Service Campaign Bulletin

Campaign No. 2018030013, April 2018

SUBJECT: **Model 906 Model Year 2016**
Check Pressure Regulating Valve

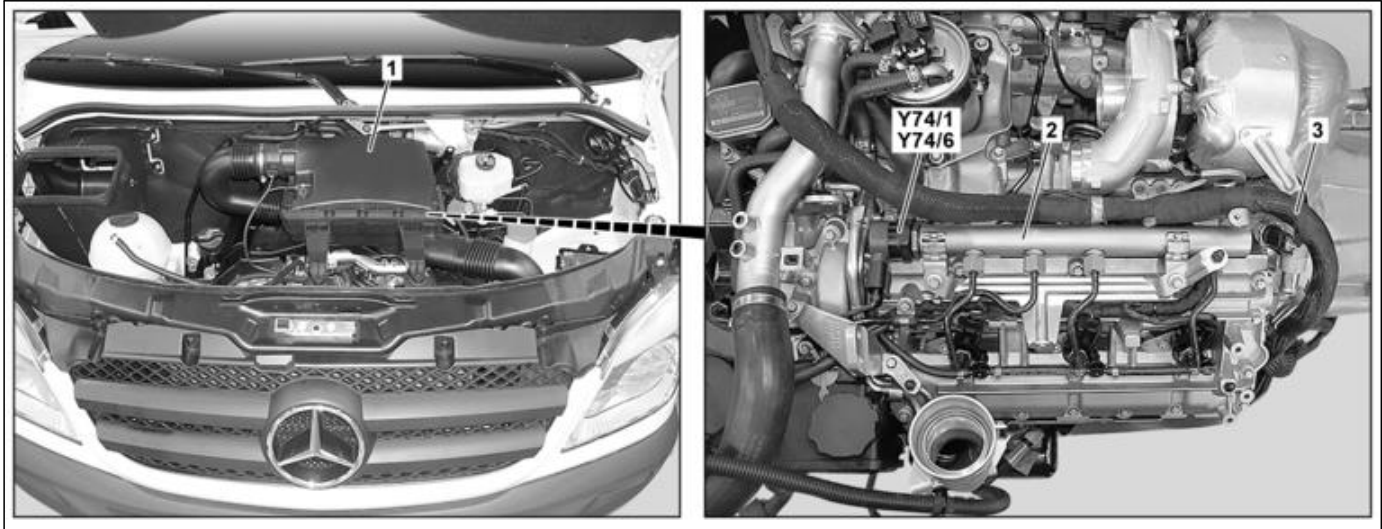
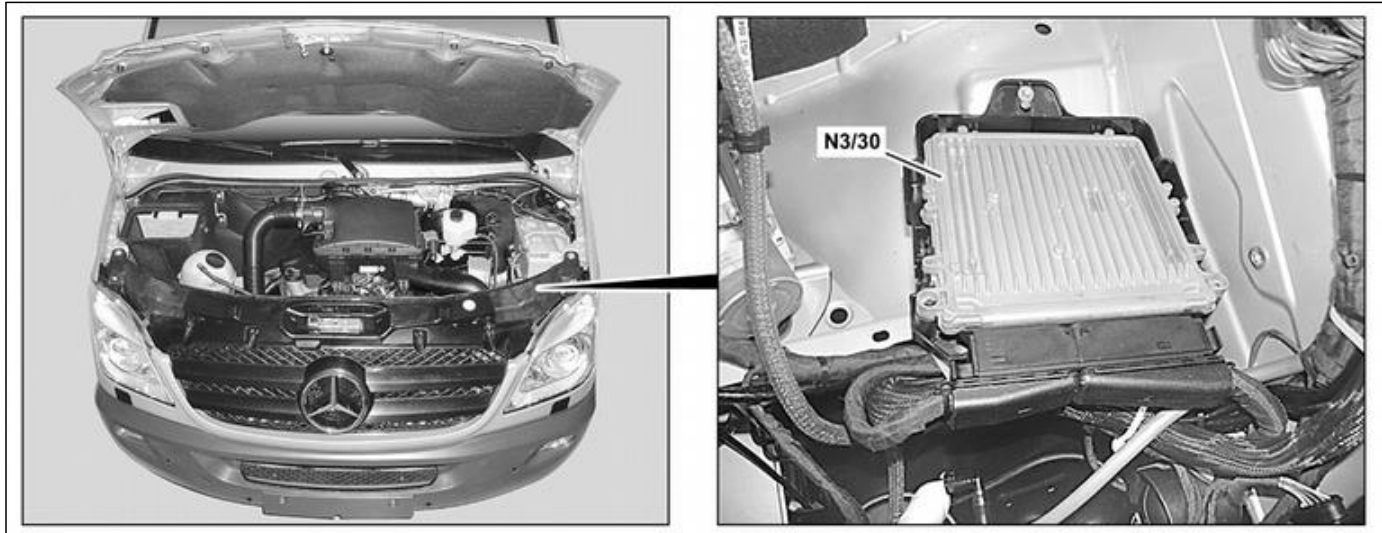
Daimler AG ('DAG'), the manufacturer of Mercedes-Benz Sprinter vehicles, has determined that on certain SPRINTER vehicles equipped with diesel engine OM642, the pressure regulating valve on the rail (fuel distributor rail of common rail system) may be slightly leaky, as two seals may not have been fitted with the required degree of precision. Consequently, very small quantities of diesel fuel could leak out along the engine wiring harness and, in the most unfavorable case, enter the engine control unit which could lead to malfunctions and possible failure of the exhaust gas cleaning system. In such an instance, the driver would be notified of the situation through activation of the engine indicator lamp in the instrument cluster. A fire hazard or a fuel leak onto the roadway can however be ruled out. Please check the affected vehicles to see if the valve on the rail has a leakage. If so, replace the affected component parts.

2.	Remove air filter housing (1)	
3.	Check pressure regulating valve (Y74/6) for leak tightness	<p>To do so, disconnect electrical connector from pressure regulating valve (Y74/6).</p> <p>Any internal leakage will be visible in the form of diesel fuel in the electrical connector. If there is no diesel fuel in the electrical connector of the pressure regulating valve (Y74/6). ↓ No measure necessary. Proceed with operation step 5. If there is diesel fuel in the electrical connector of the pressure regulating valve (Y74/6). ↓ Proceed with operation step 4.</p>

4.	Check electrical connectors of the CDI control unit (N3/30) for the presence of any diesel fuel	<p>To do so, disconnect electrical connectors from CDI control unit (N3/30). If diesel fuel is not present in the electrical connectors of the CDI control unit (N3/30). ↓ Replace engine wiring harness (3) and rail (2). If diesel fuel is present in the electrical connectors of the CDI control unit (N3/30). ↓ Replace CDI control unit (N3/30), engine wiring harness (3) and rail (2).</p>
